Access Compliance Report

Public Rights-of-Way

(Curb Ramps)

Intersection ID: 24499	Main Street: BECKMORE_PL	Cross Street: SAINTFIELD_PL	Location: NE
ADA ID: 8B638DA8AD39	Ramp Type: Perp	Initial Pass/Fail: Pass	Overall Compliance: No
Severity Score: 2.5			
Codes/Mitigation Info/Possible Solution		Field Measurements/Component Compliance

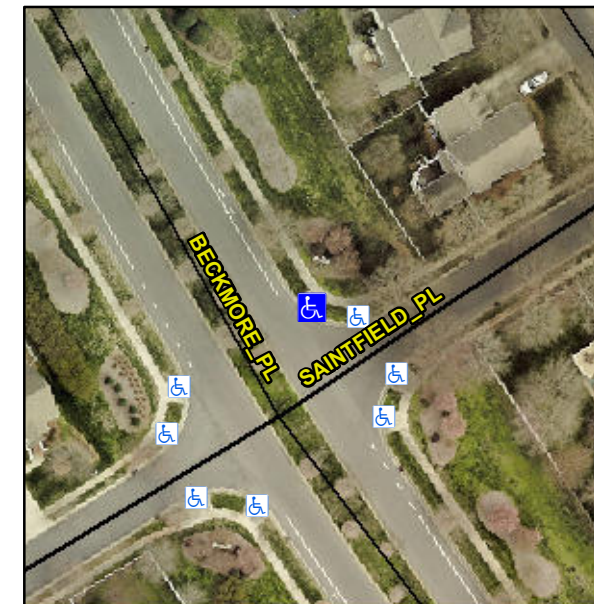
Not Found, R305.1.4, R305.2

Compliance	Description	Data	Compliance	Description	Data
N/A	Ramp Length (in)	94.0	Yes	Ramp Slope (%)	7.7
Yes	Ramp Width (in)	71.0	Yes	Ramp XSlope (%)	1.4
N/A	Flare Type LT	Sloped	N/A	Flare Type RT	N/A
N/A	Flare Slope LT (%)	8.8	Yes	Flare Slope RT (%)	8.1
N/A	Flare Traversable LT?	Yes	N/A	Flare Traversable RT?	Yes
Yes	Landing Length (in)	62.0	Yes	DWS Provided?	Yes
Yes	Landing Width (in)	71.0	Yes	DWS Contrast?	Yes
Yes	Landing Slope (%)	2.0	Yes	DWS Length (in)	25.5
Yes	Landing X Slope (%)	1.6	No	DWS Full Width?	No
N/A	Landing Curb? (Y/N)	No	No	DWS Offset (in)	3.0
N/A	Shared Landing?	No			
Yes	Gutter Ponding?	No	Yes	Gutter Slope (%)	2.0
Yes	Gutter Lip Ht (in)	0.0	Yes	Gutter X Slope (%)	1.0
N/A	Painted X Walk1?	No	N/A	Painted X Walk2?	N/A
	X Walk 1 Direction	To W		X Walk 2 Direction	N/A
N/A	X Walk 1 Width (in)	N/A	N/A	X Walk 2 Width (in)	N/A
	X Walk 1 Slope (%)	2.4		X Walk 2 Slope (%)	N/A
	X Walk 1 X Slope (%)	8.9		X Walk 2 X Slope (%)	N/A

N/A	Ramp inside XWalk1?	N/A	N/A	Ramp inside XWalk2?	N/A
	Road Slope (%)	N/A	N/A	Clear Space?	Yes
	Road X Slope (%)	N/A	N/A	Clear Space to XWalk (in)	N/A
Yes	Any Obstructions?	No	Yes	Storm Grate/Utility Hazard?	No
	Obstruction Type			Storm Grate/Utility Type	
		N/A			N/A
			Yes	Surface Condition? (G/P)	Good

Remove & Replace Entire Ramp.
